Field Service Bulletin Trucks

SB-10055176-2663

HDMS Cool Logic Fan Drive
CHU, CXU, GU, TD

(February 2014)

W2086676

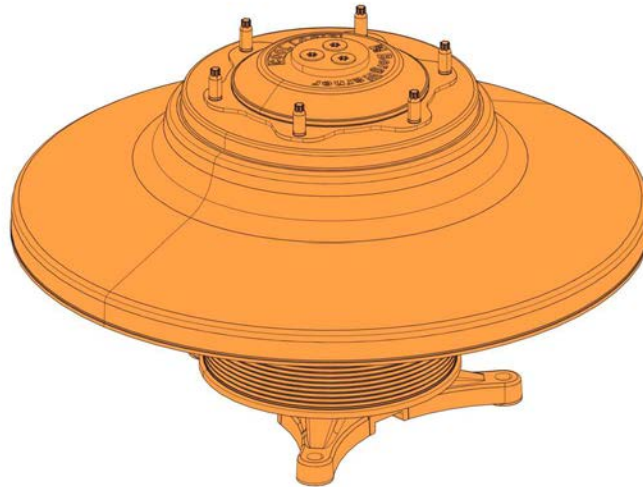
Vehicles built before January 6, 2014 equipped with the HDMS Cool Logic engine cooling fan drive may experience a fluid leak from the rear of the drive. Due to this leakage the HDMS fan drives have been redesigned in conjunction with improvements to the manufacturing process to improve sealing and overall durability of the drive.

The new parts are available in the PDC and have been implemented into production. These new parts should be used to replace the previous units on a fix as fail basis.

Refer to service information in Function Group 26 for fan drive replacement. Refer to the table below for the affected part numbers.
